Subject: Response to Questions/Requests for Information (Ref No. 20848/Conf No EA102058)

In reference to your correspondence (Reference No. 20848) on the Checkpoint Systems, PV2000 (8.2 MHz Version, FCC ID **DO4PV20008-2**, (731 Confirmation No EA1020581), I have the assembled the following information and responses for your review. For clarity, I have included your text followed by my comments.

Figure 1 – Correction Factor Chart for the BBH-500/B Broadband Magnetic Field Antenna

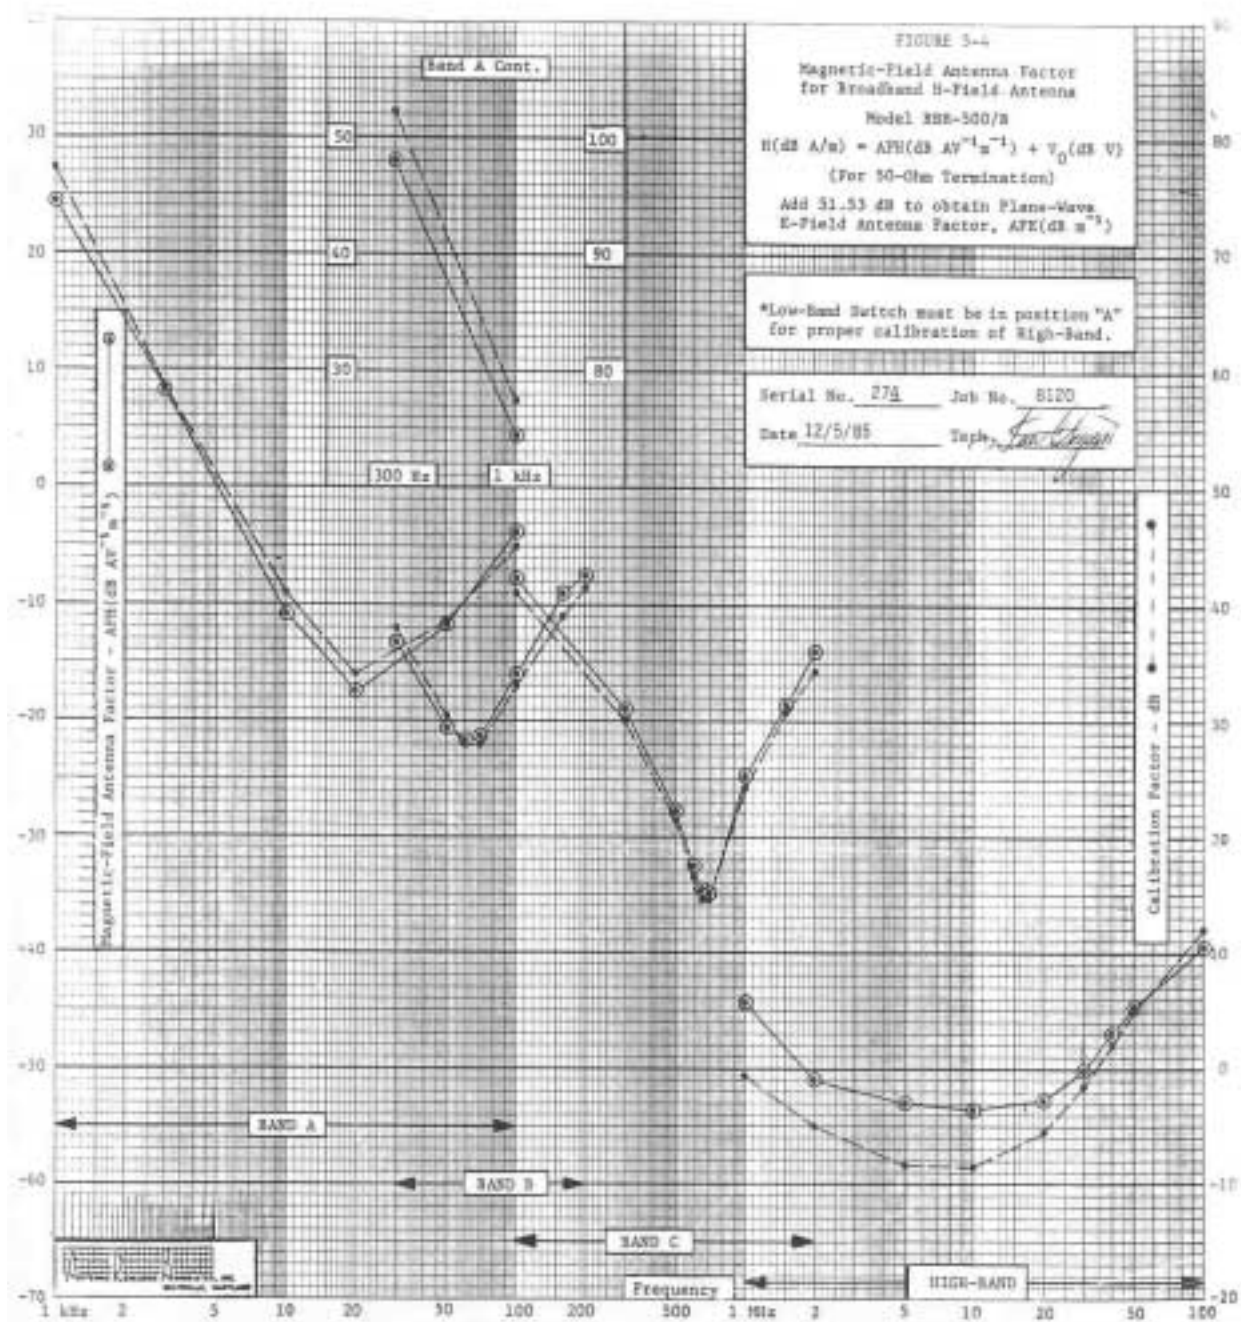
COMMENT 5: Provide the Antenna correction chart for antennas used. Electric field measurements must be made.

RESPONSE 5:   Two antennas were used during the measurement of emissions from the EUT as identified below. The chart of correction factors for the magnetic field antenna is shown below in Figure 1, and a table of the correction factors for the E-Field antenna is shown in below in Figure 2.

As can be seen from the chart, at 8.2 MHz, the magnetic field correction factor is approximately -53 dB. A factor of 51.5 dB must then be added to convert the resultant H-Field measurement to an E-Field. The overall correction factor for a final E-Field measurement is then approximately –1.5 dB.
